ND-08-1577

Southern Nuclear Operating Company
Vogtle Early Site Permit Application Reference Changes

Proposed Reference Changes

AP1000 Vogtle Site Seismic Evaluation Report

Figure 3-3 - Acceleration Response Spectra – Input Outcrop Motion at 40 ft Depth

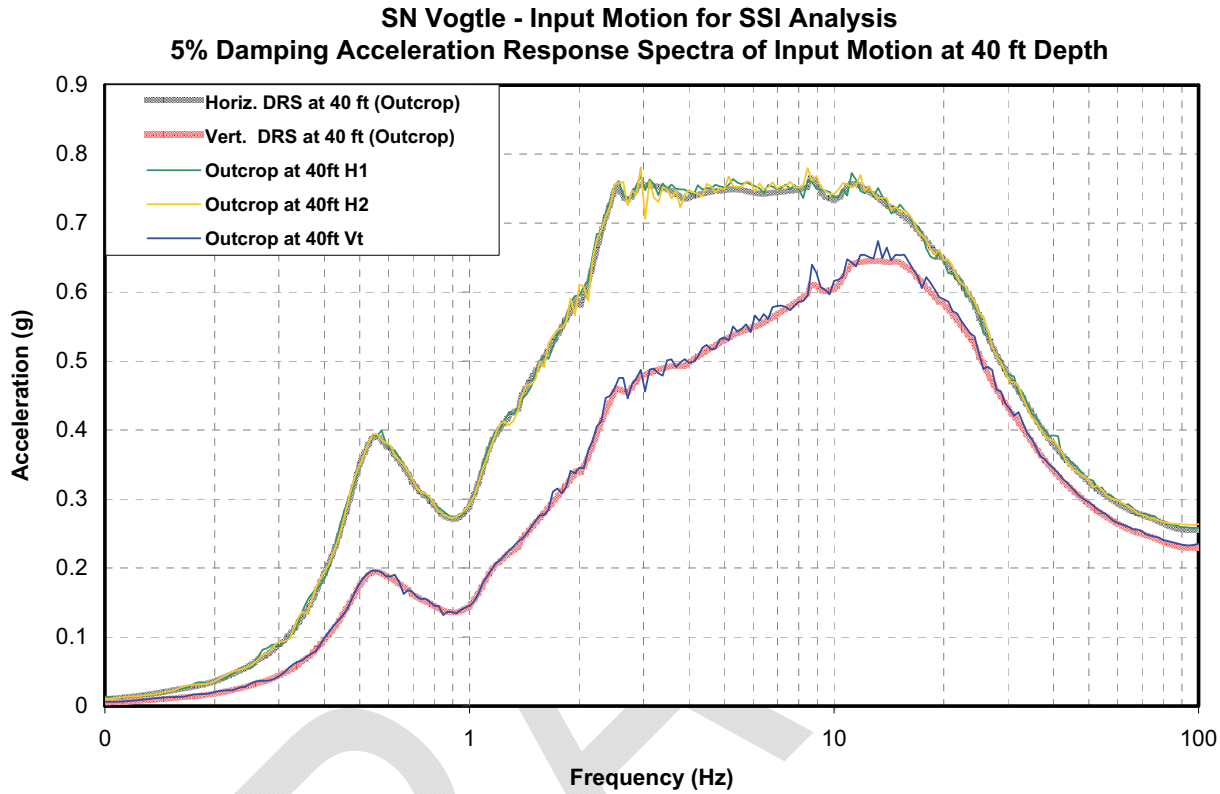
Rev	Date	Revision Description[1]
0	See EDMS	Original Issue
1	3/20/08	Comments addressed from Southern Company, Bechtel, and Shaw.
2	3/24/08	Changed note on Figure 3-3 from "Note: DRS = GMRS" to "Note: DRS = FIRS".
3	8/12/08	Revised section 2.0, 3.0, 6.0, 7.0, Table 5.1-2 and Figure 5.1-1 to 5.1-36. Add Section 5.3 and Appendix A.
4	10/2/08	Eliminated reference to DCD and replaced Reference 2

Note: DRS = FIRS
